UNITED STATES PATENT AND TRADEMARK OFFICE

APPLICATION NO.	FILING DATE	FIRST NAMED INVENTOR	ATTORNEY DOCKET NO.	CONFIRMATION NO.
10/811,037	03/26/2004	Thomas E. Falgout SR.	530	9542

Office Action Summary

ANNOTATED SHEET

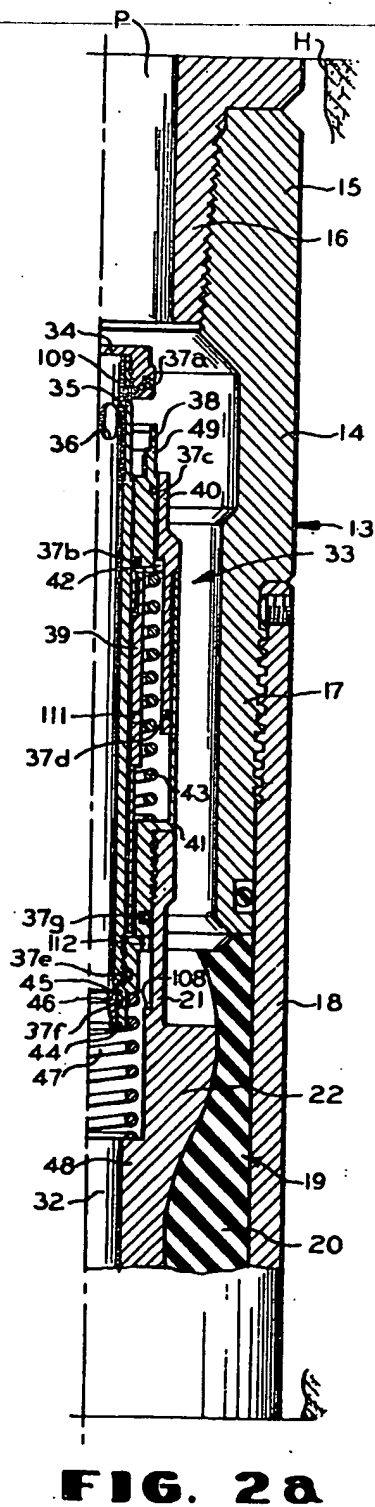
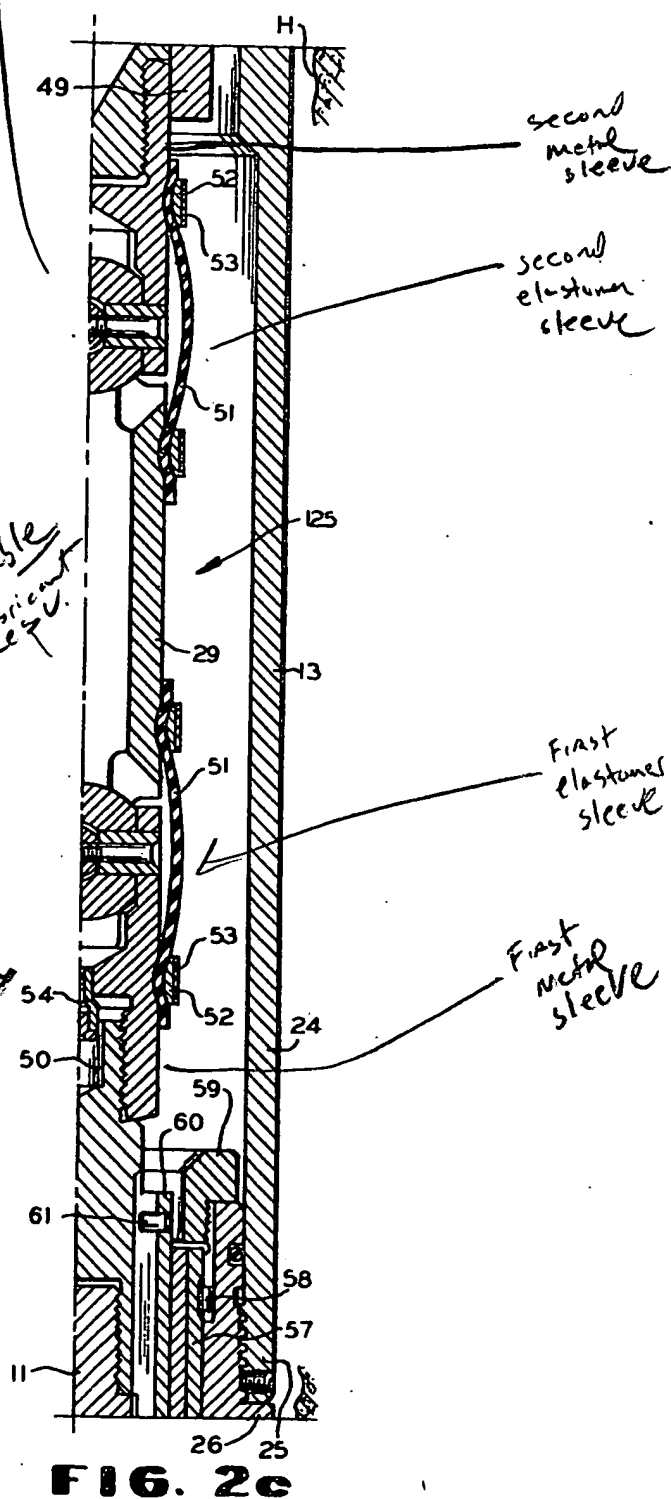
10. Claims 1-4, 6 & 7 rejected under 35 U.S.C. 102(b) as being anticipated by Beimgraben, US 4,263,788. Figs. 1 shows a coupling assembly 29 for connecting, as an axially serially continuation, a down hole motor rotor 21 to the down hole motor output shaft 11. Fig. 2c shows the coupling assembly 29 comprising (see the annotated copy attached): a first flexible coupling, having a lubricant space therein, arranged for connection, at a first end, to the output shaft 11; a second flexible coupling, having lubricant space therein, arranged for connection at a third end to the first coupling and arranged, at a fourth end arranged for connection to the motor rotor 21; a first flexible seal situated in the first flexible coupling, arranged to function as a closure for the lubricant space between the first and second ends, the seal comprising a first metal sleeve sealingly and peripherally attached at one end of the first coupling, a first elastomer sleeve sealingly and peripherally attached at one end to the distal end of the first metal sleeve sealingly and peripherally attached at the other end to the other end of the first flexible coupling; a second

flexible seal situated in the second flexible coupling, arranged to function as a closure for space between the third and fourth ends, the seal comprising a second metal sleeve sealingly and peripherally attached to one end of the second coupling, a second elastomer sleeve peripherally attached at one end to the distal end of the second metal sleeve and "sealingly peripherally" attached at the other end to the other end of the second flexible coupling; and two variable lubricant reservoirs with fluid channels to provide lubricant to the couplings.

second flexible coupling

first flexible coupling
